Item No. 114 WHEEL TRACKING.

JAVELIN & JUPITER

Liner Flange.

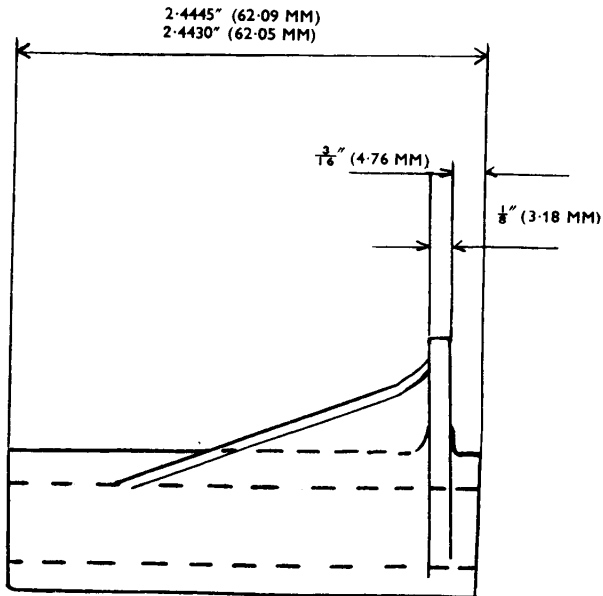
Service experience has indicated that due to the lateral variation both on the inside face of the Wheel Flange where the tyre fits, and on
